Advanced FEA Crack Growth Calculations for Evaluation of PWR Pressurizer Nozzle Dissimilar Metal Weld Circumferential PWSCC

Sponsored by: EPRI Materials Reliability Program

Status Meeting on Implications of Wolf Creek Dissimilar Metal Weld Inspections

April 4, 2007, NRC Letter

Figure 11: SIF Along Crack Front

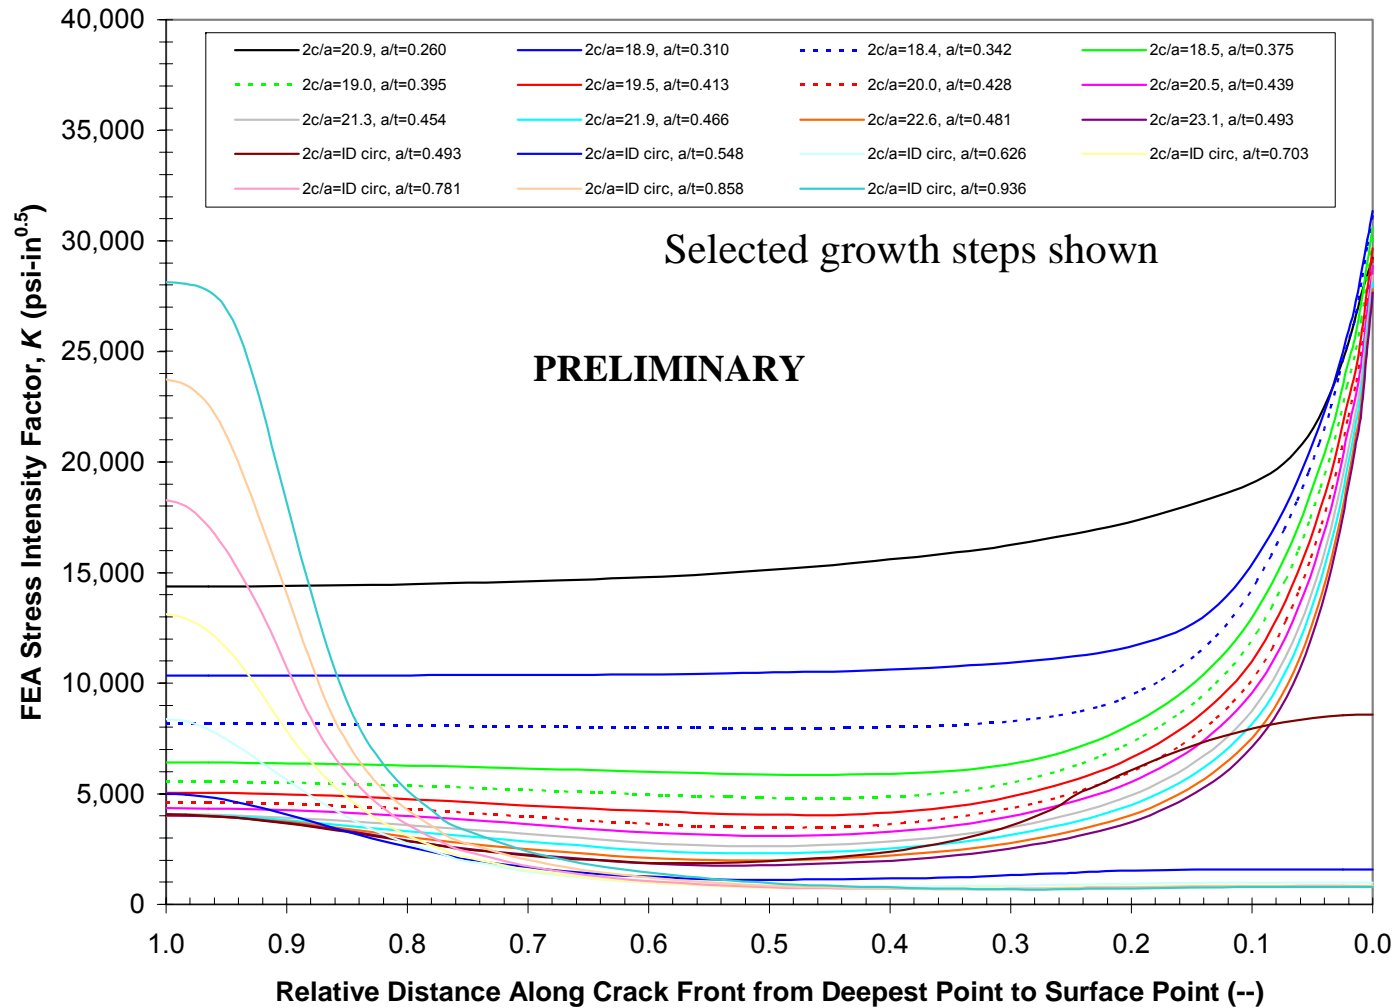
- *Comment #2.* In Figure 11 of industry's Phase I calculations on the evolution of the stress intensity factors, a discontinuity occurred after the second increment of crack growth, and appears to occur at the same stress intensity for each of the remaining steps. Industry's response to a question on this observation during the March 20, 2007, teleconference was unclear, but industry indicated they believed the response was real. We suggest further investigation into the mesh density or the crack increment calculation is warranted. It is recognized that this effect is probably secondary in nature.

- *Response.* The observed behavior is a real effect in terms of the stress intensity factor being locally high where the crack front profile is not smooth. In recent work, DEI has concluded that this behavior observed in the draft Phase I calculation was an artifact of the crack growth increment size. Reducing the crack increment along the ID circumference results in a fully behaved stress intensity factor profile. The new results for the Phase I calculation inputs confirm that this issue in fact had a small effect on the crack profile at the point of through-wall penetration.
